**World Forum for Harmonization of Vehicle Regulations****Working Party on General Safety Provisions****125th session**

Geneva, 27–31 March 2023

**Event Data Recorder:****UN Regulation No. 160 (Event Data Recorder)****Proposal for Supplement 2 to the Original Version of UN  
Regulation No. 160 (Event Data Recorder)****Submitted by the expert from the Informal Working Group on Event  
Data Recorder / Data Storage System for Automated Driving \***

**Corridor +/- 10 Per Cent of the Full-Scale Range of the Accelerometer**

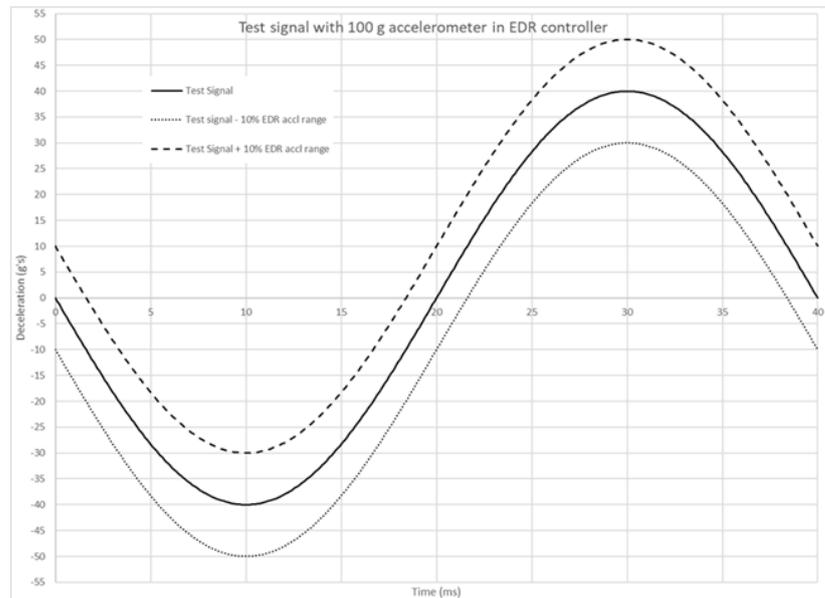
- 6.1.5. The EDR recorded acceleration trace shall be fully contained in a corridor that is +/- 10 per cent of the full-scale range of the accelerometer used by the controller containing the EDR applied to the component test fixture's filtered acceleration trace. The comparison of acceleration sensor traces shall only be made on the axis the component test was conducted.

For example, if the accelerometer in the controller containing the EDR function has a +/- 100 g range, then +/- 10 g would be applied to the component test fixture's filtered acceleration trace. The EDR recorded acceleration trace shall be fully contained within that corridor (see the Figure).

- 6.1.6. **The EDR acceleration trace in paragraph 6.1.5. can be time shifted up to +/- 2ms based on the inverse of the 500 Hz sample rate to further align the data. The minimum step of the time shift may be the inverse of the sample rate of the EDR.**
- 6.1.7. **The acceleration data elements satisfy the tolerance condition if the EDR recorded acceleration trace is fully contained within the corridor established in paragraph 6.1.5., with or without following the above time shift in paragraph 6.1.6.**
- 6.1.8. **If the recommended waveform cannot realize algorithm wakeup due to the reason of manufacturer’s algorithm strategy, the manufacture may select a waveform, or amplify the suggested waveform. The waveform used for the EDR acceleration data accuracy shall be provided for review, if it is different than the waveform defined in the verification process."**
